Adapt XE Fitment Check

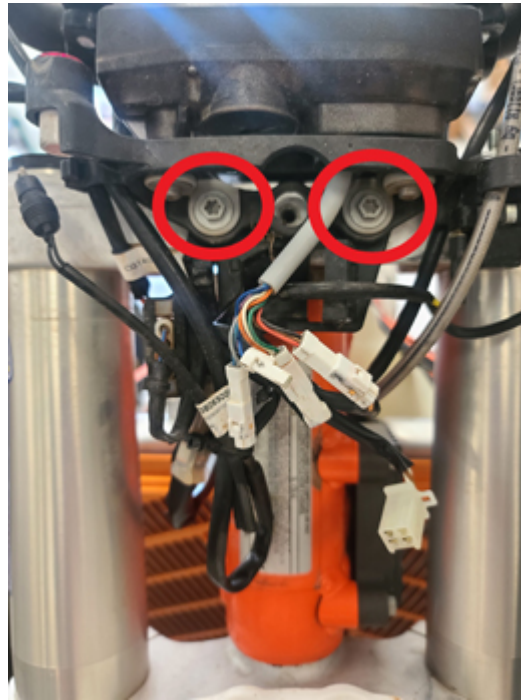
Bike Year	Make	Model	Stock Headlight (Y/N)?	Install Issues (Y/N)?	Describe Issues If Any	Work Around for Issue
2021	Husqvarna	FE501	Y	Y	<ol style="list-style-type: none">1. Plastic plate behind stock number plate that holds wire harness blocks user from installing mount plate (see attached photos).2. Regulator installed between center column and fork tube catches bottom tube clamp and prevents bike from full turn.	<ol style="list-style-type: none">1. Remove two bolts holding plastic piece in place (see photos). Remove plastic and mount wire harness without this piece (fully turn bike side to side to make sure your new location does not cause wires to pinch). Replace two bolts to secure speedometer back into place. Tube clamp that was blocked previously will now fit.2. Option 1, relocate regulator to new position which does not block lower tube clamp. Option 2, dremel off some of the material from the tube clamp in that position to allow clearance of the regulator, allowing a full turn (see photos).
